TOWN OF BRIDGEWATER

PLANNING BOARD MEETING

DATE: 7 June 2017

TRINITY CIRCLE PUBLIC HEARING CONTINUATION

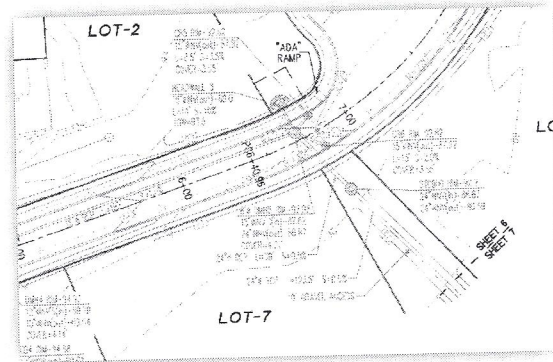
TE Comment 2: The existing deficient stormwater conduit from Ashtead Road has not been properly accounted for, albeit the culvert size that conveys runoff from Forest Street under the existing driveway is being upgraded;

SEA Response: The nomographs for documenting compliance were inadvertently labeled "existing" and not "proposed." I have revised the heading and included a summary in the table below.

Headwater Depth for each Storm Event:

Existing 1 – 18"	Proposed 2 – 24"
2-year	96.1	94.4
10-year	99.4	94.8
25-year	102.1	95.1
50-year	105.1	95.3
100-year	107.4	95.7

The elevations of the runoff flowing through the culvert are reduced with the larger sized culverts also stormwater will not flow over the new roadway at elevation 98.
